NOTICE OF DECISION

Tumwater 30
TUM-22-1608
October 9, 2023

RE: Formal Site Plan Review Approval – TUM-22-1608
Tumwater 30 - Multi-Family Residential 42 Apartment Units
723 Israel Road SW, Tumwater, WA 98501
Tax Parcels 82700300101, 82700300106, & 827003100107

SITE PLAN

A101
202206

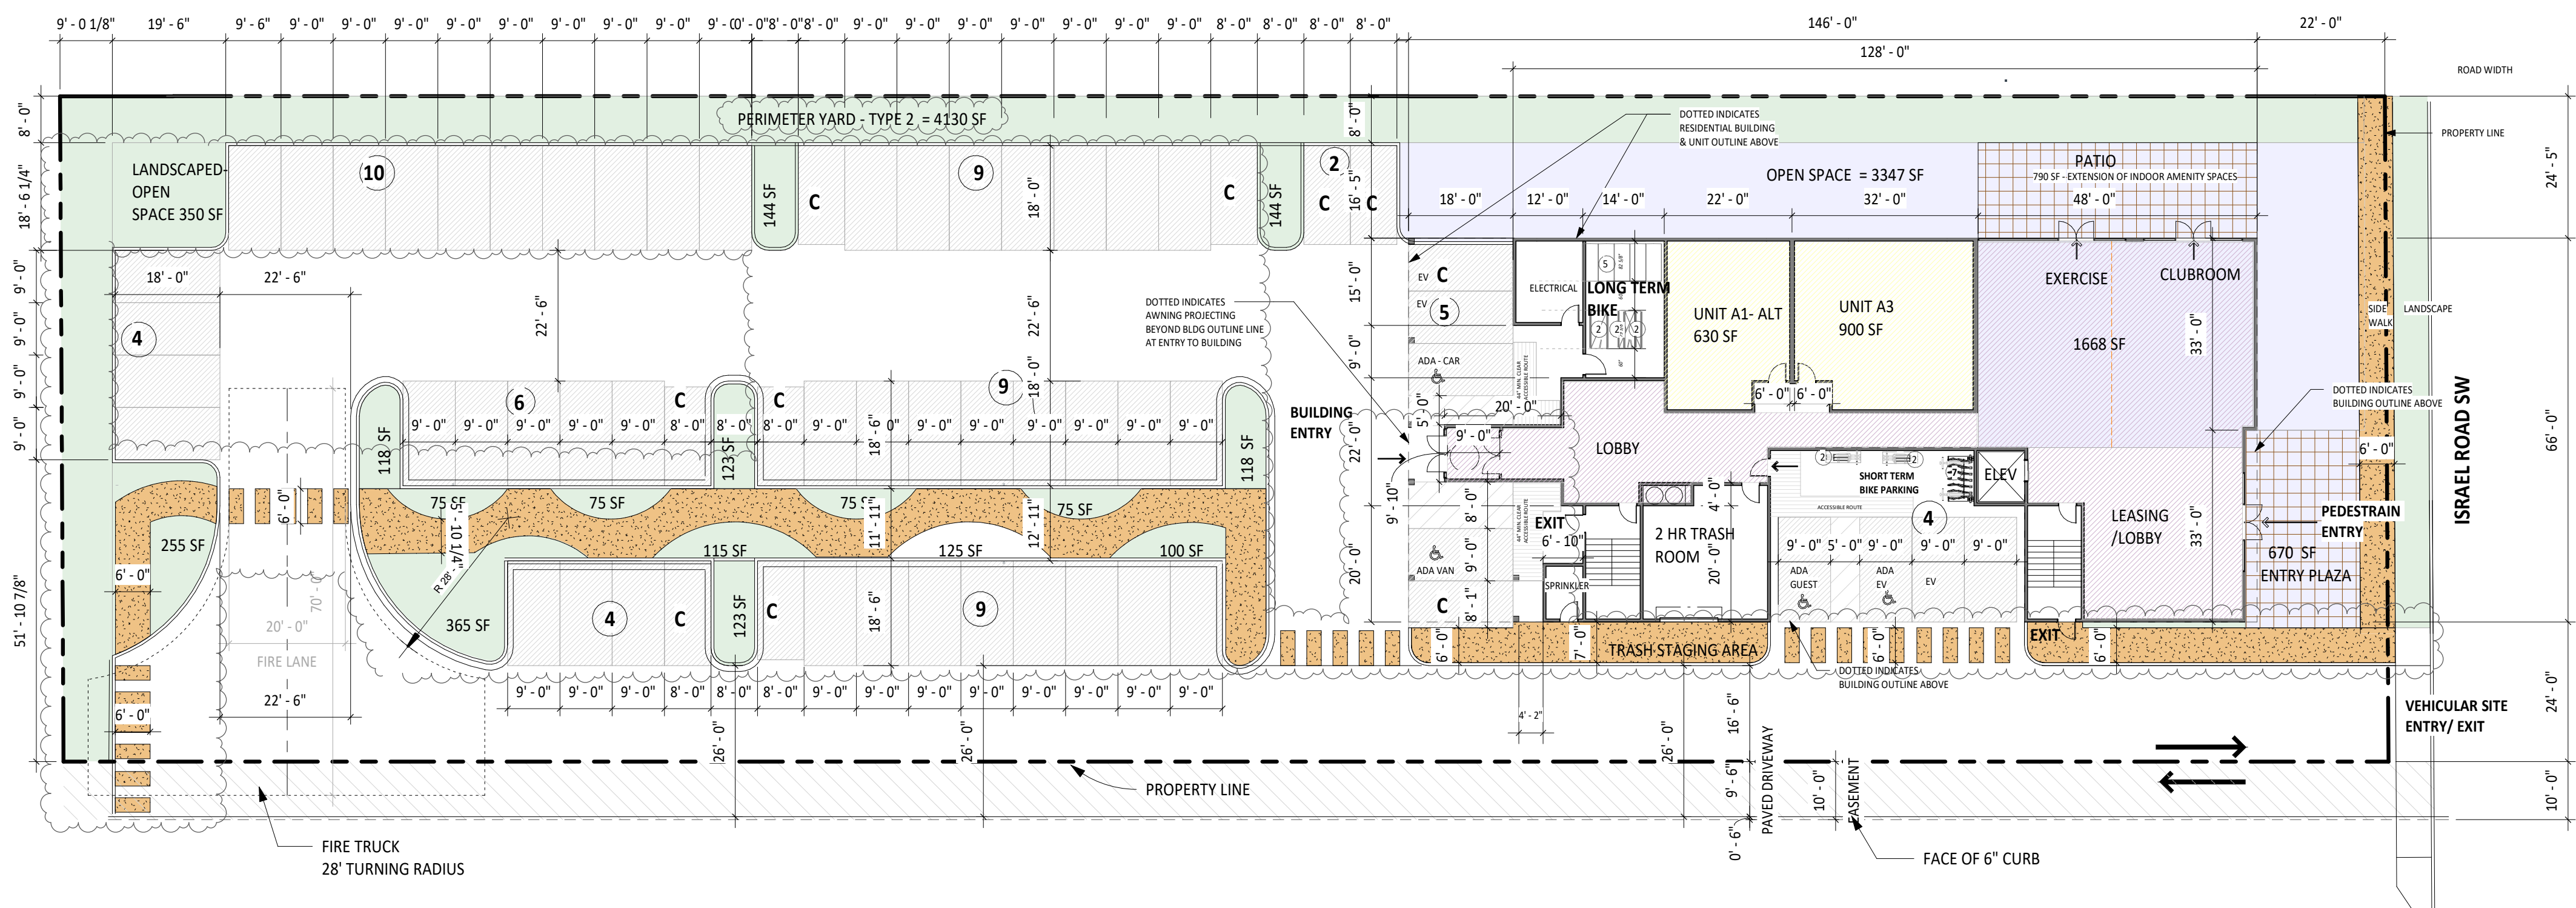
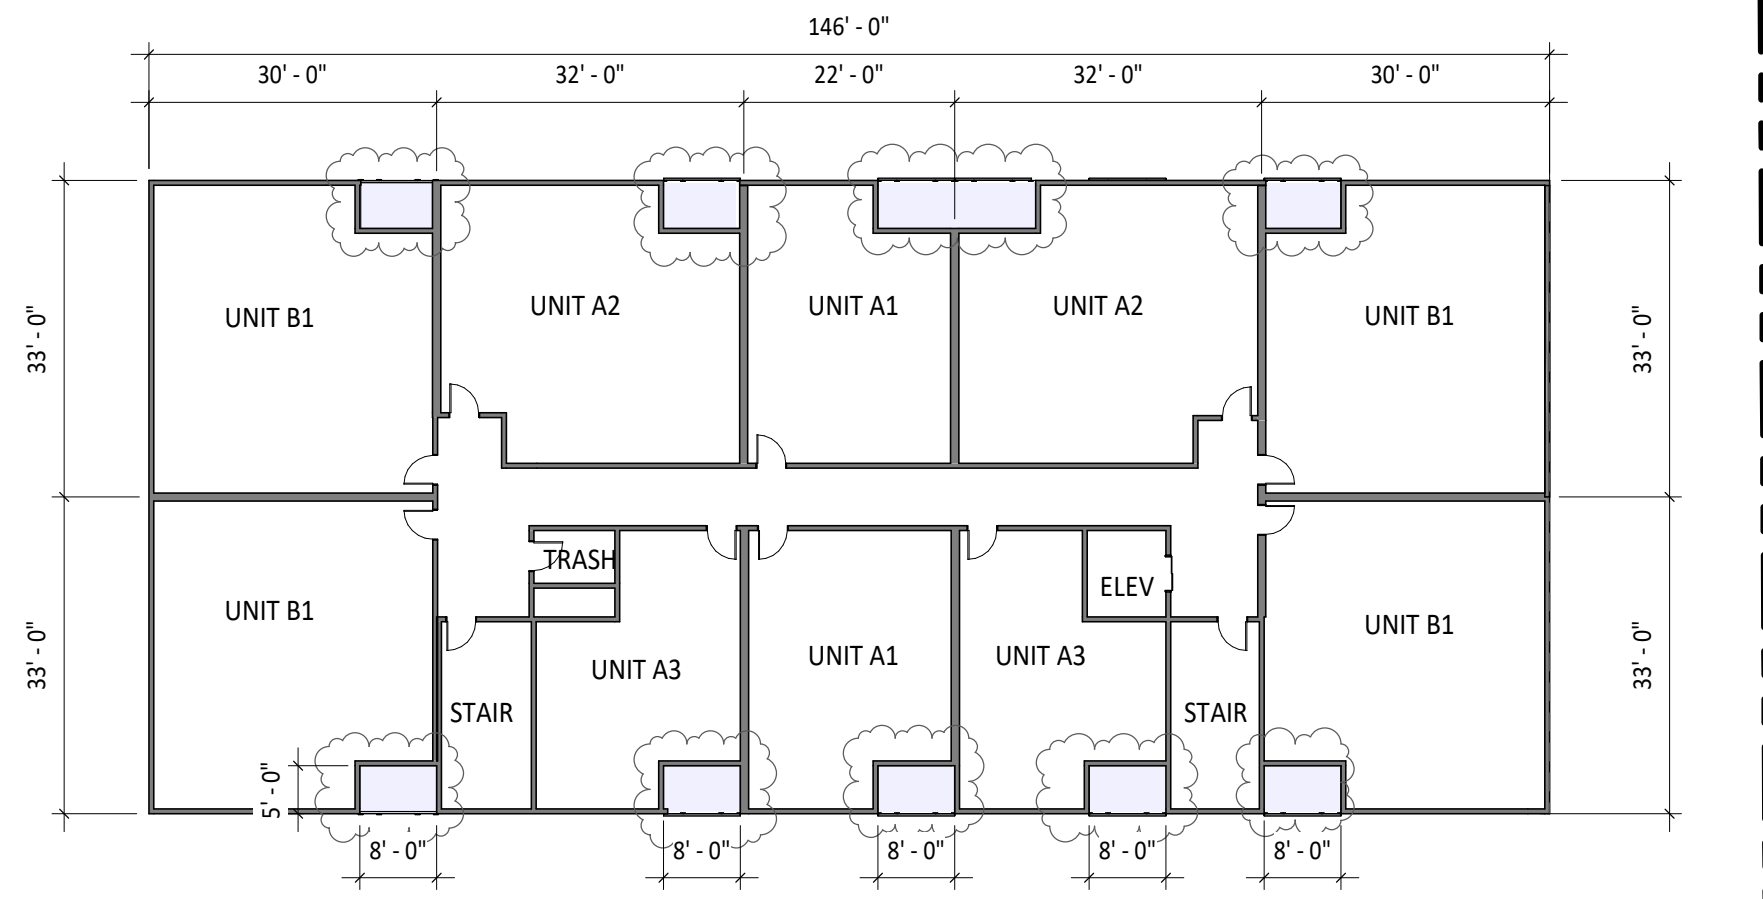
1. Use: The proposed project is located within the Town Center Residential Subdistrict of the Town Center Zoning District, Aquifer Protection Overlay Zoning District and Wellhead Protection Area (16.26). Residential is a permitted use within these zones at a minimum density of 30 units per acre, and shall comply with 18.23.030. [Chapters 18.23 & 18.39 TMC]

3. Parking: Minimum requirements subject to TMC 18.50

1.5 spaces per 1 – 2 bedroom dwelling unit, with 1 guest space for every 10 units. (Note: Can be reduced to 1.0 spaces per 1 – 2 bedroom dwelling unit if within one-half mile of a transit stop by sidewalk or paved path.)

Parking spaces must utilize approved wheel stops to prevent vehicle overhang of a sidewalk or walkway or planter bed where a tree is within three feet of the curb. These need to be shown on the site plan.

Maximum parking without pedestrian walkway is 180'. Please add internal circulation to each phase where it exceeds 180'

Bike facilities are required to be covered. Show the location of the bike facilities on the formal site plan.

up, and shall be available to occupants and haulers. The location of this facility shall be shown on the site plan.

The site plan as proposed shows 42 dwelling units, meeting minimum density requirements.

The site plan as proposed meets the minimum requirement of TMC 18.50.

The site plan as proposed shows appropriate landscape areas. A detailed landscape plan is required as part of site development and grading application submittal.
